**Amendments to the Drawing Figures:**

## **REMARKS**

**Fig. 2**

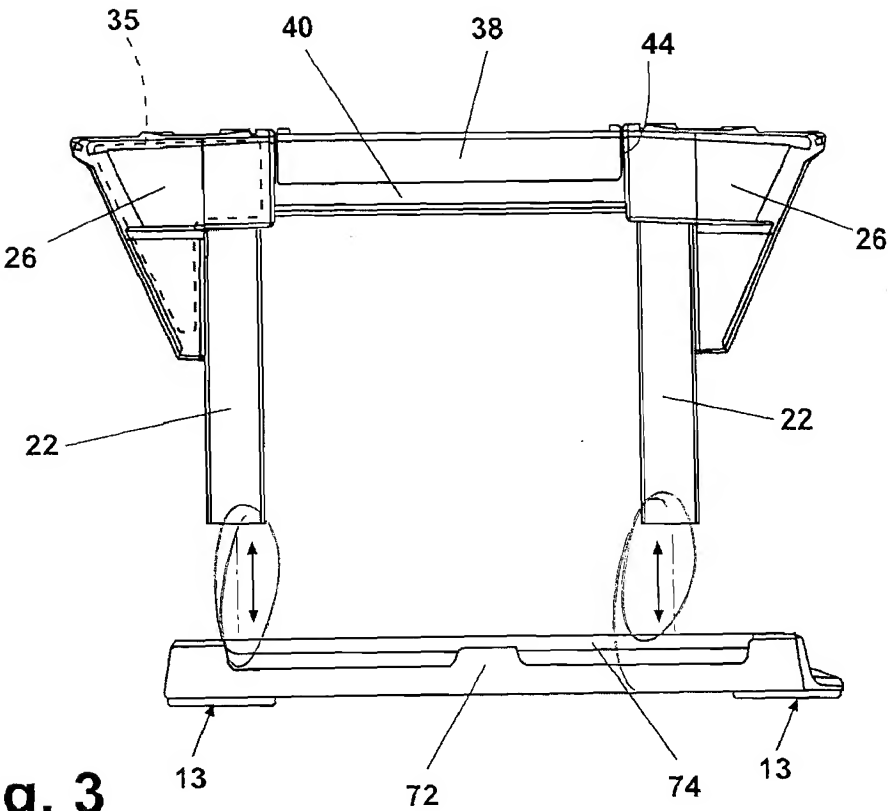
The drawing figures submitted previously have been amended to remove any structure deemed to constitute new subject matter. In particular the lines outlining the recess receiving the upright support members have been removed. A set of drawing figures showing the proposed changes are attached with the proposed change enclosed within the circled regions.

The drawings were objected to because they failed to show that the electrical socket was attached to a power supply of the vehicle, and that the framework assembly could be removed from the base assembly as claimed and described in the patent specification.

The drawings have been amended as illustrated by the annotations accompanying this response. Moreover this issue has also been addressed by amending the claims. In particular the claims citing a power socket or electrical supply have been cancelled or

amended to remove the reference. The drawings have also been amended to reflect the modular nature of the invention consistent with the Examiner's earlier indication this feature, if placed in independent format, would place the application in condition for allowance.
